**Instruction No. K14
Proposed Public Housing Redevelopment
at Pak Tin Estate (Phase 12)
Environmental Assessment Study (EAS)**

Draft Final Report (Revision 1)

Proposed Public Housing Redevelopment at Pak Tin Estate (Phase 12)
Environmental Assessment Study (EAS) EPD's comment regarding submission of the captioned EAS report (September 2023)

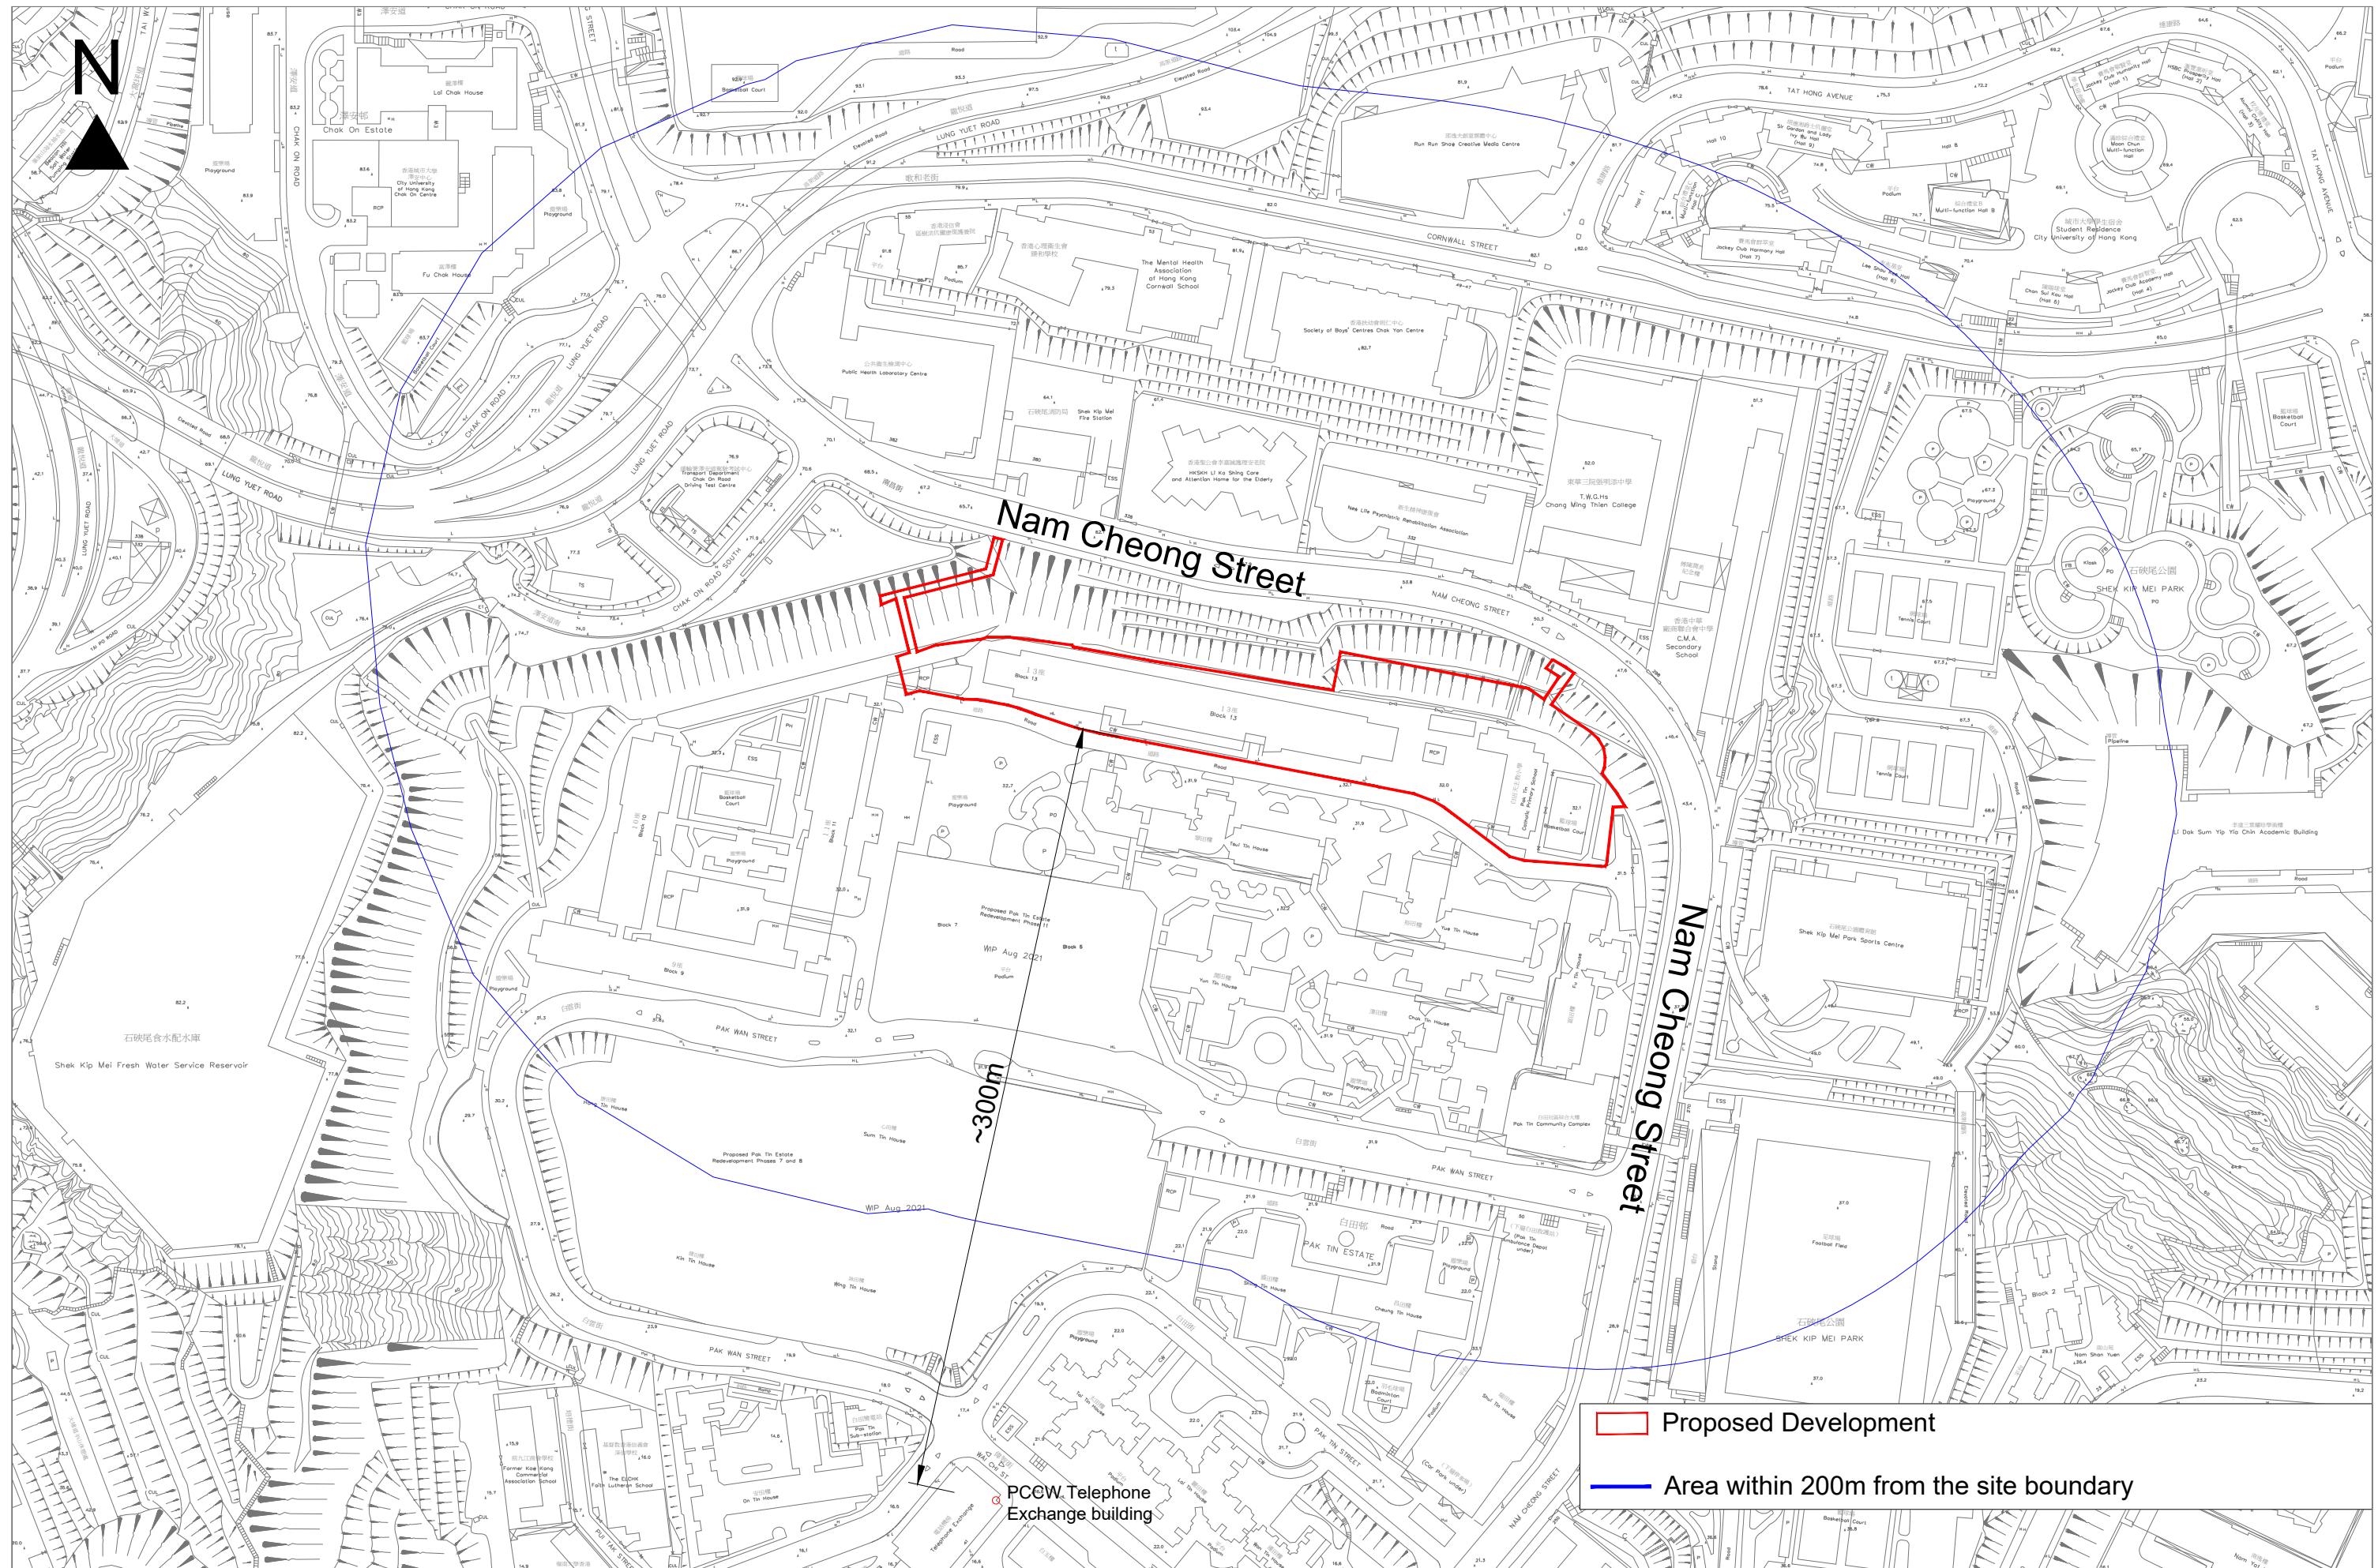
5.	Section 2.4.7 - The word "Flat" should read "Flat". Please check.	Text revised.
6.	Section 2.4.17 -	
	(a) Both window settings are proposed and indicated on Figures 2.5, 2.6 and 2.7. Please check if the settings are indicated	Figures 2.5, 2.6 and 2.7 are updated.

As built drawings for road side barrier along Nam Cheong Street

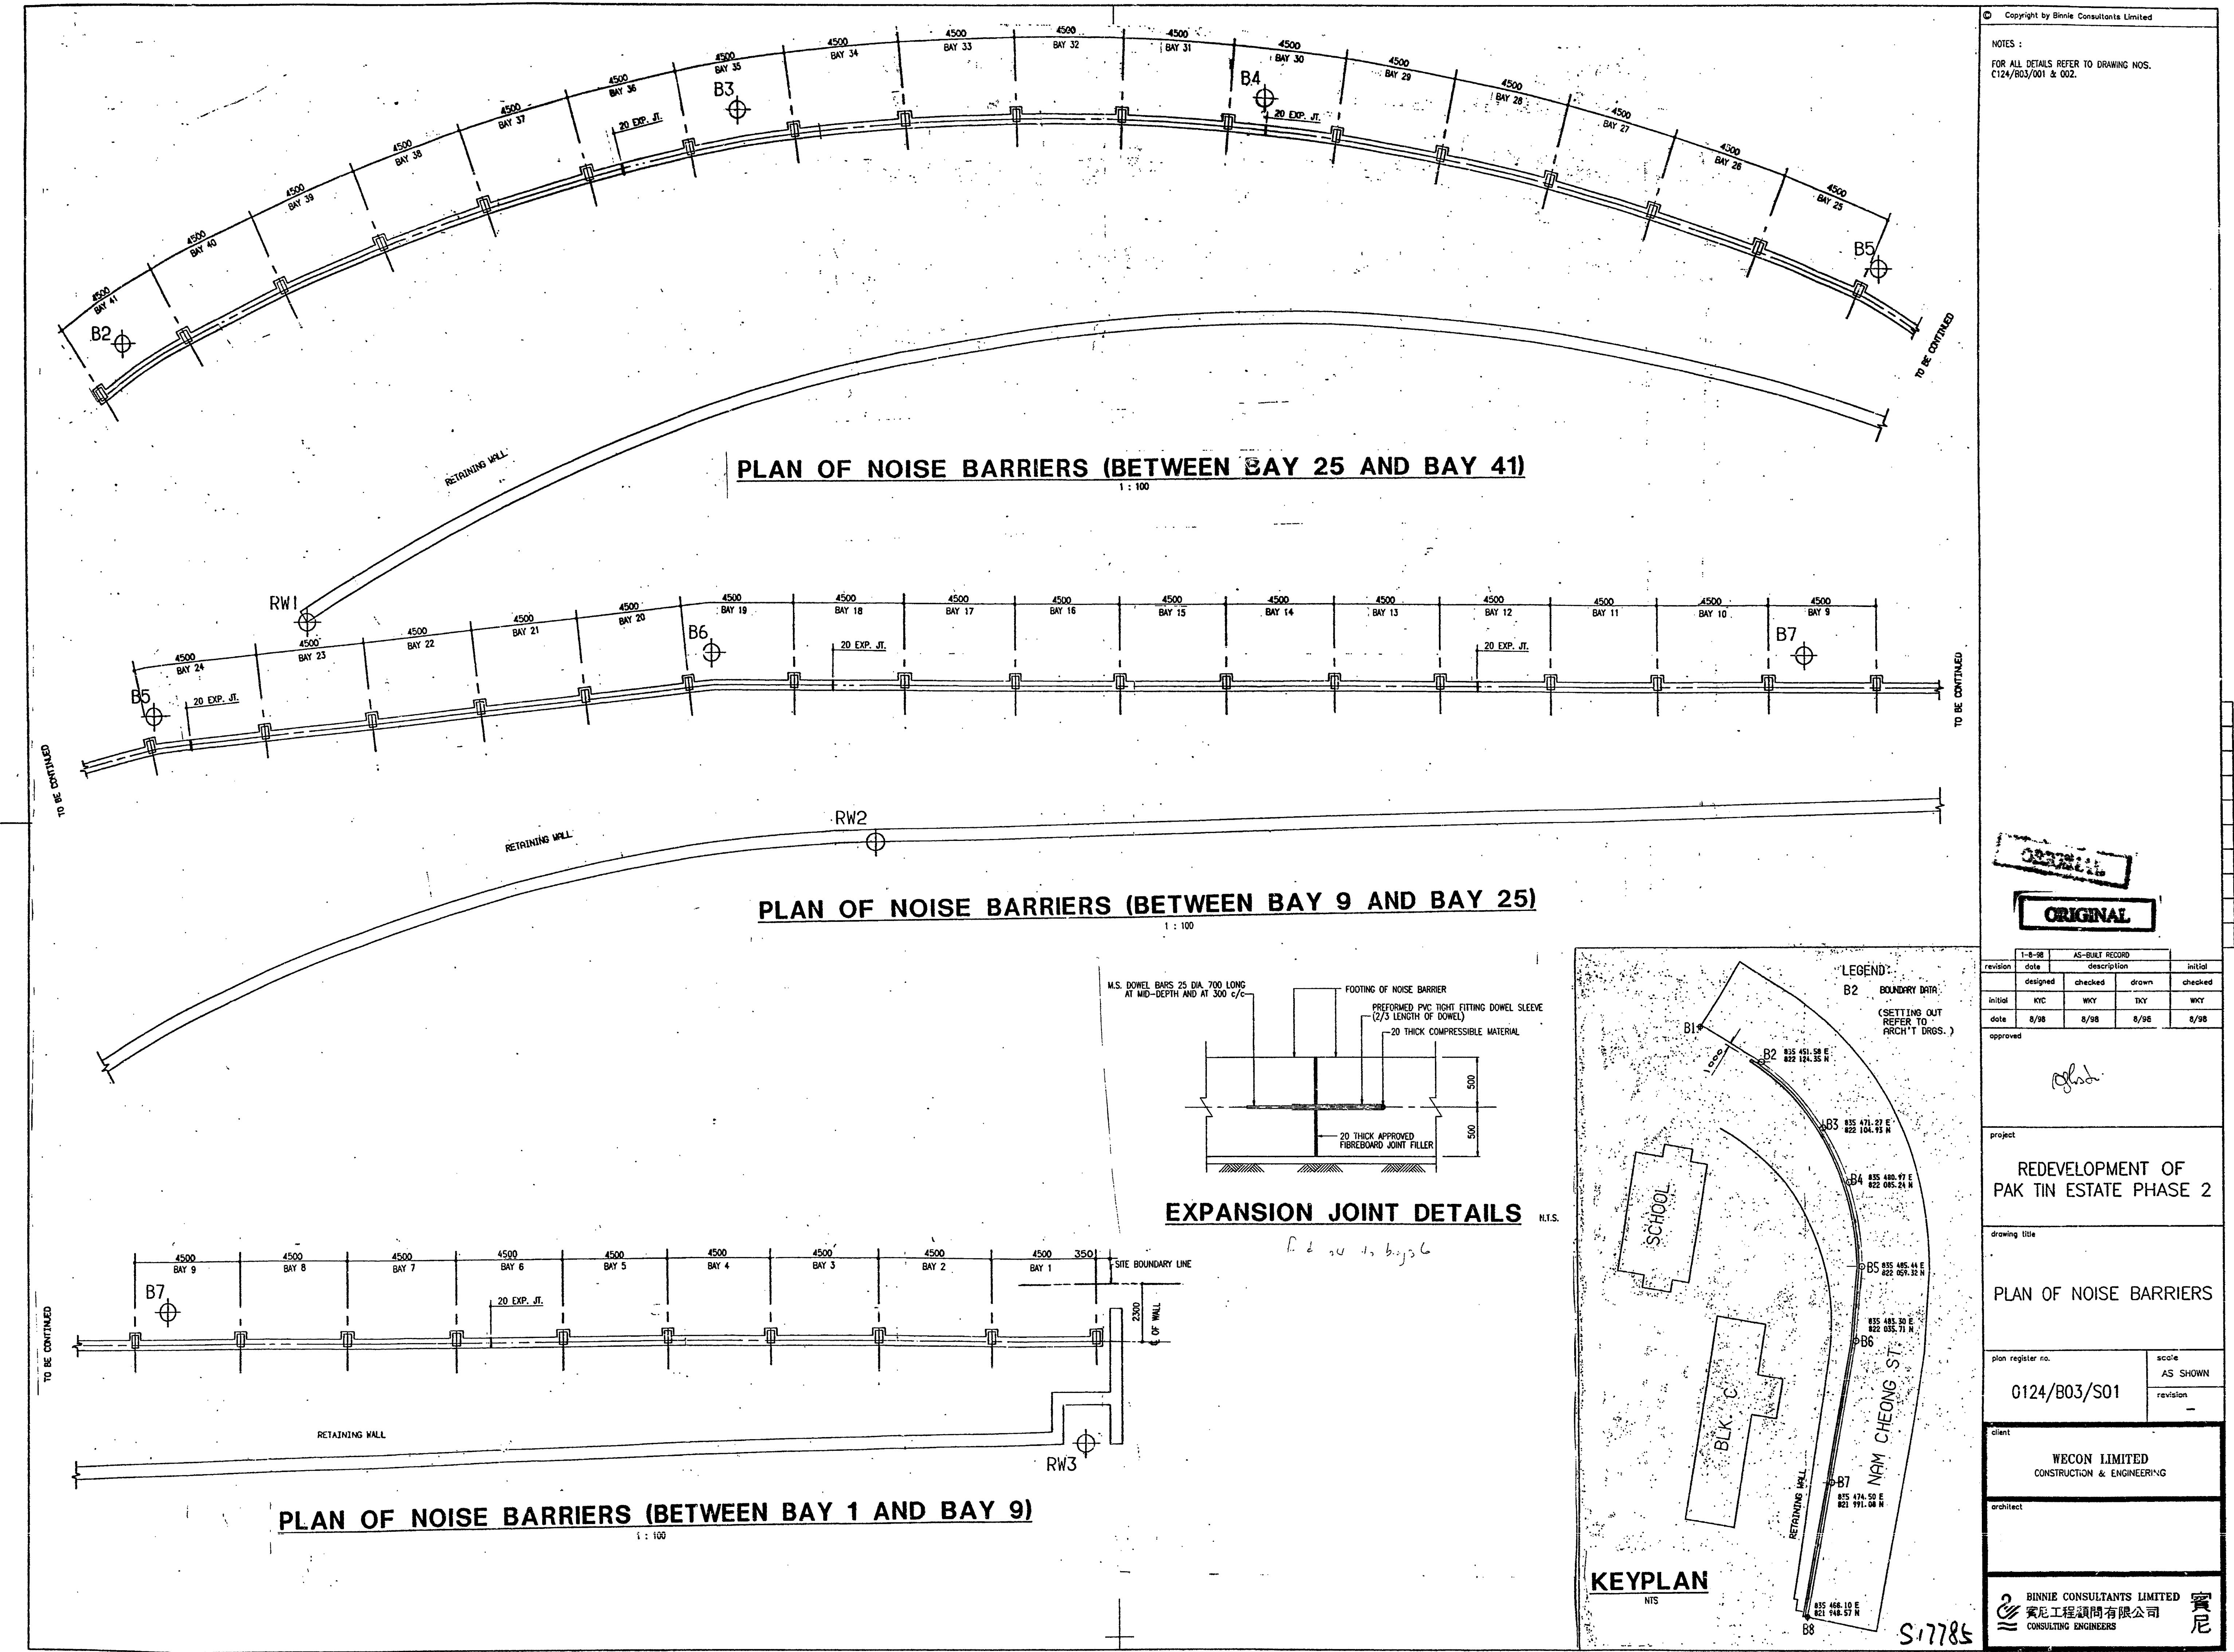
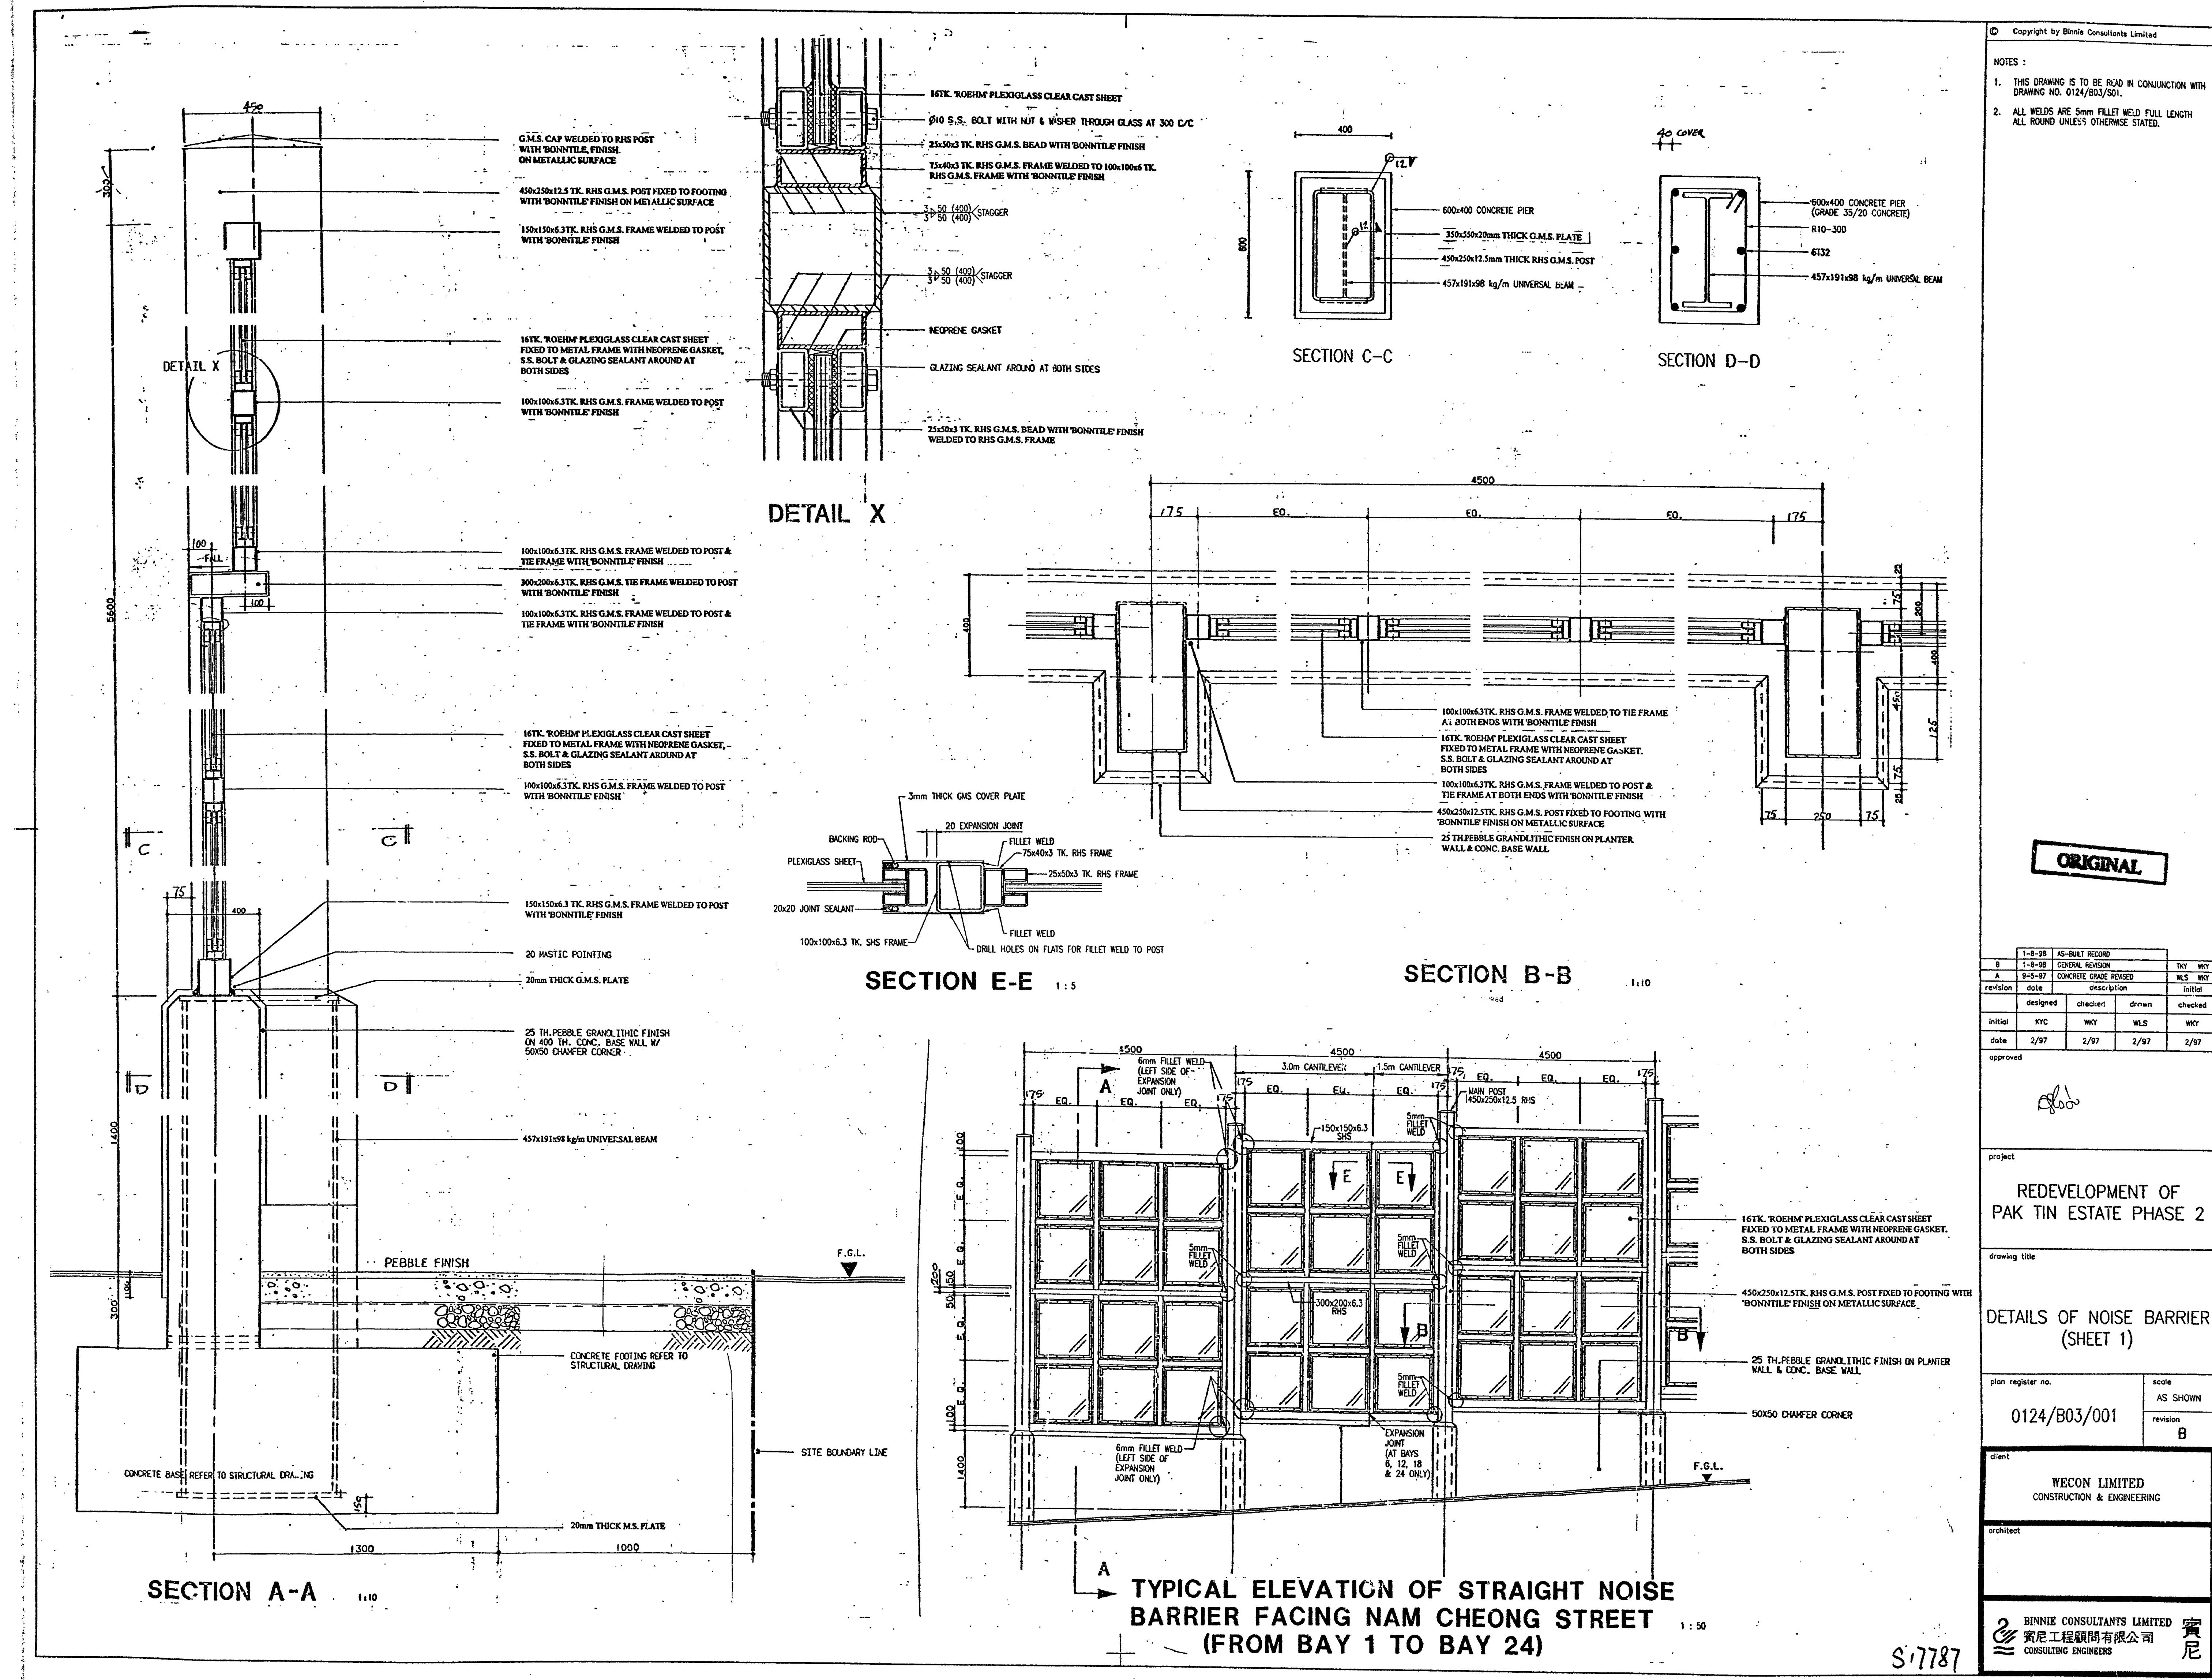
(b)	According to Section 2.3.7, the existing roadside noise barrier is 7m high. Please clarify and check if the height of a section of existing barriers opposite to Shek Kip Mei Park Sports Centre has been input correctly or not.	The noise model is rectified.
